Culebrinas River Flood Control Project

**Prepared by Beverly Yoshioka
U.S. Fish and Wildlife Service
Boqueron Field Office**

November 1999

Executive Summary

Figure 3. Original Alternative 2 from Section 205 Reconnaissance Report, 1992.

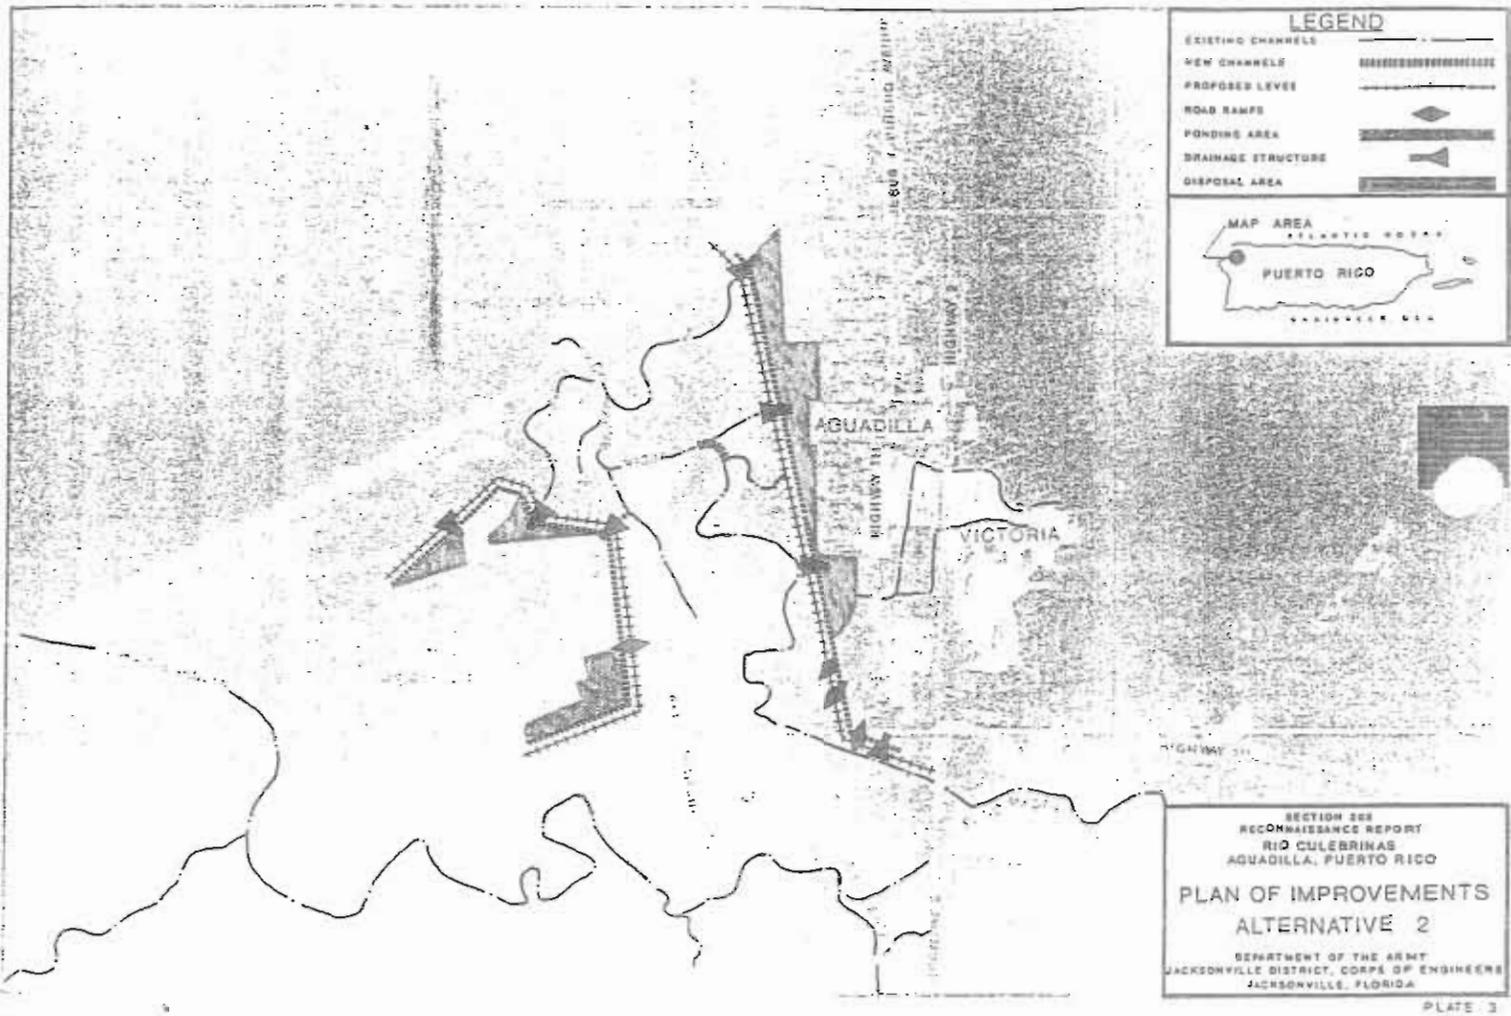
The original version of the two-levee alternative (Figure 3) included a flood ring levee immediately adjacent to the south, east and north sides of Espinar community. The variation to include the church could still be used within this alternative. That alternative would have impinged on the mangrove channel immediately adjacent to the northeast part of Espinar community, but would have remained south of the back-berm herbaceous and forested wetlands and Coastal Barrier Unit PR-75 and it would have avoided impacts to the sedge dominated wetlands south of the mangroves. The mangroves that would be impacted could be mitigated by relocating the portion of the channel to be impacted slightly eastward and replanting mangroves.
